APPLICATION No. H01/0958/93

Refusal of Planning Permission

Description: Erection of boundary wall

Location : Peak Hill House Peak Hill
Cowbit Spalding, Lincs

Amended Plan

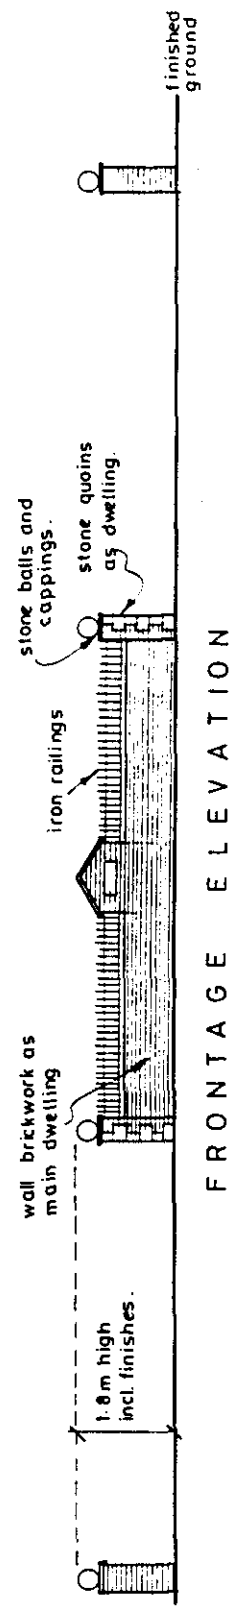
After taking a look at the new plan submitted, I find no alterations regarding the layout at front, which makes it impossible to see around the bend at oncoming traffic, has been made. I now have 2 relatives not calling on me again due to them having a very close shave coming out, as they dare not risk their lives.

I therefore object to the new plan which
was submitted and trust a site meeting from
my drive be made at your earliest convenience
as winter is rapidly approaching.

Fig. 1

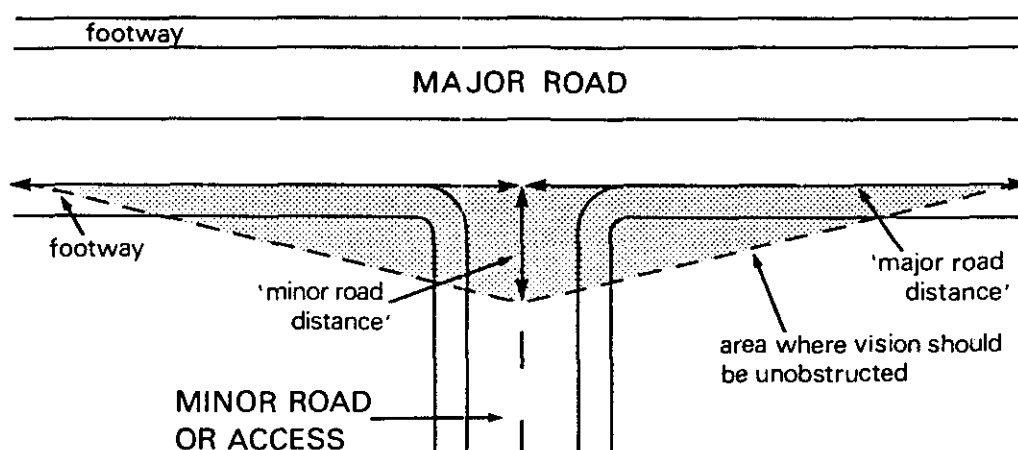
5. Where an emerging vehicle crosses a footway at a lightly used access, for example from the driveway of a proposed dwelling, pedestrians will not have sufficient warning of its approach. A splayed opening will normally be needed for this purpose. Unless a suitable alternative standard has been adopted by the local planning authority, the splay should extend from the back of the footway for a "minor road distance" of 2.4m and for a similar "major road distance" along the back of the footway. Where the footway is likely to be used by small children, there should be clear visibility at a level of 0.6m above road level, in addition to visibility at the 1.05m level.
